Deputation to Council on the proposed Barrie Lakeshore Development December 7, 2020

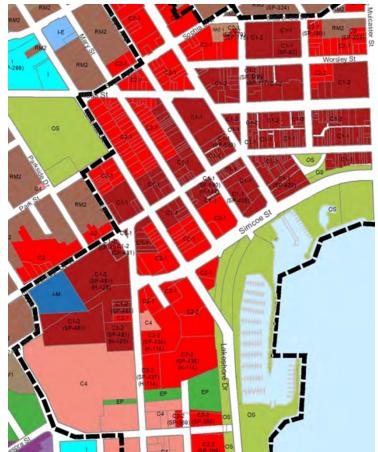
i) Where taller buildings are located next to lower scale buildings, design elements which make use of height transitions between sites shall be encouraged. Towers should be located on site away from areas directly adjacent to lower scale buildings.
